Re Iwatsu Claim Report

As already have sent telexes, we will enclose here the report on rejected C.R.T. Questionnaire W-223 for 9 pcs which we would like to have your analysis of the tubes.

From Sales Organization	: Nihon Philips Corporation	
Type No.	: D13-500GH/01	
Invoice No.	: 540/0262.02	540/0254.02
Invoice Date	: 1976-10-29	1976-10-19
Defective Q'ty	: 6 pcs	4 pcs (*)
Tube No. ;	518969, 524499	546071, 524515
	518946, 618843	522913
	618841, 442923	
Order No. :	642-313, 345, 046	642-345

1. 518969

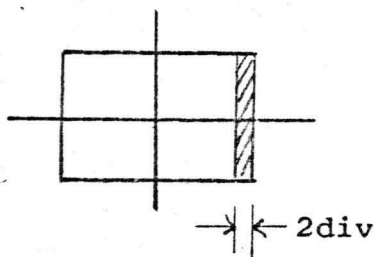
*Adjustment of tube at approx. 8 μ A beam current and displaying sin wave. By shifting sine wave in X direction sine wave disappears from screen at approx. 2 divisions from right hand side (deshadow effect).(A)

*Too high cathode current for optimal focus setting.
